DEVELOPMENT REVIEW COMMITTEE (DRC) COMMENT REPORT

PROJECT NAME: 3000 Alhambra

CASE NUMBER: PDD19001

REQUEST: Site Plan Level IV Review: Rezoning from A-1A Beachfront Area (ABA) District to Planned Development District (PDD) with Site Plan Approval for 159 Multifamily Residential Units, 5,150 Square Foot Restaurant Use, and 125 Public Parking Spaces

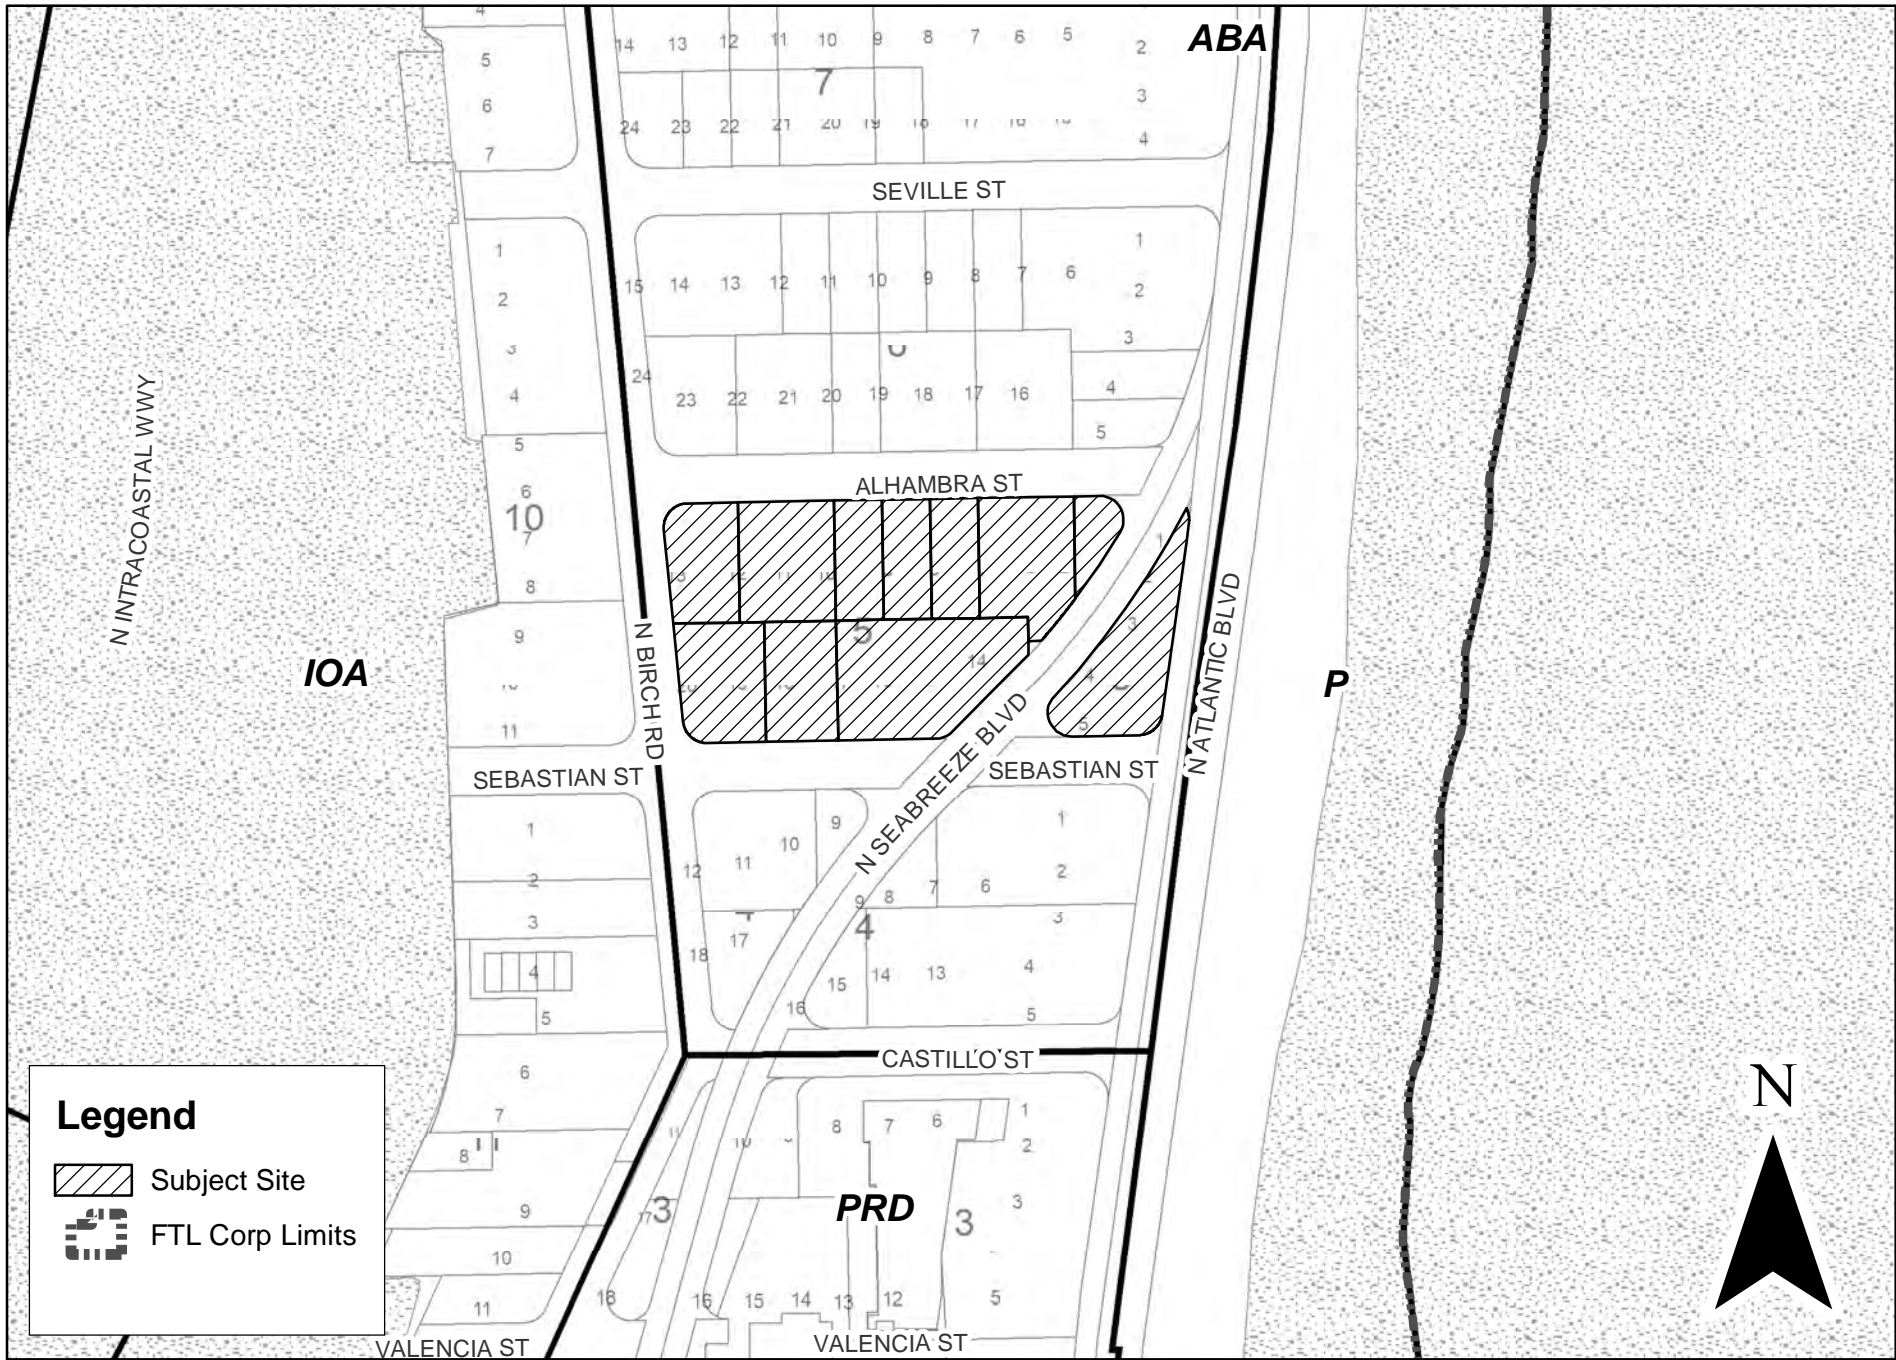
23. It is unclear how many spaces are being provided for bike parking and storage. Indicate on plans such information.
